Access Compliance Report

Public Rights-of-Way

Intersection ID: N/A	Main Street: GLENBURN_LN	Cross Street: MOSSDALE_LN	Location: NE
ADA ID: 1078FEE18161	Ramp Type: PerpDiag	Initial Pass/Fail: Fail	Overall Compliance: No
Severity Score: 1.25			
Codes/Mitigation Info/Possible Solution		Field Measurements/Component Compliance

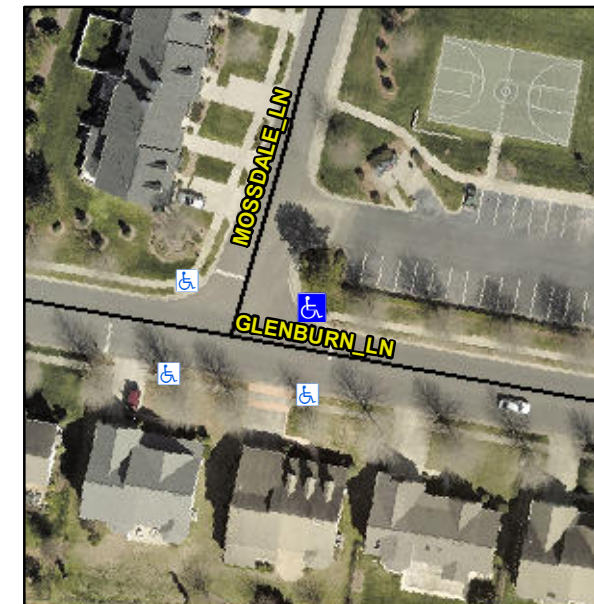
Not Found, R304.5.3

Compliance	Description	Data	Compliance	Description	Data
N/A	Ramp Length (in)	49.0	Yes	Ramp Slope (%)	5.8
Yes	Ramp Width (in)	52.0	No	Ramp XSlope (%)	2.3
N/A	Flare Type LT	N/A	N/A	Flare Type RT	N/A
N/A	Flare Slope LT (%)	N/A	N/A	Flare Slope RT (%)	N/A
N/A	Flare Traversable LT?	N/A	N/A	Flare Traversable RT?	N/A
N/A	Landing Length (in)	N/A	N/A	DWS Provided?	N/A
N/A	Landing Width (in)	N/A	N/A	DWS Contrast?	N/A
N/A	Landing Slope (%)	N/A	N/A	DWS Length (in)	N/A
N/A	Landing X Slope (%)	N/A	N/A	DWS Full Width?	N/A
N/A	Landing Curb? (Y/N)	N/A	N/A	DWS Offset (in)	N/A
N/A	Shared Landing?	N/A			
N/A	Gutter Ponding?	N/A	N/A	Gutter Slope (%)	N/A
N/A	Gutter Lip Ht (in)	1.0	N/A	Gutter X Slope (%)	N/A
N/A	Painted X Walk1?	No	N/A	Painted X Walk2?	No
	X Walk 1 Direction	To NW		X Walk 2 Direction	To SW
N/A	X Walk 1 Width (in)	N/A	N/A	X Walk 2 Width (in)	N/A
	X Walk 1 Slope (%)	2.4		X Walk 2 Slope (%)	4.0
	X Walk 1 X Slope (%)	3.2		X Walk 2 X Slope (%)	1.3

Remove & Replace Curb Ramp With Two New Directional Ramps or Equivalent.
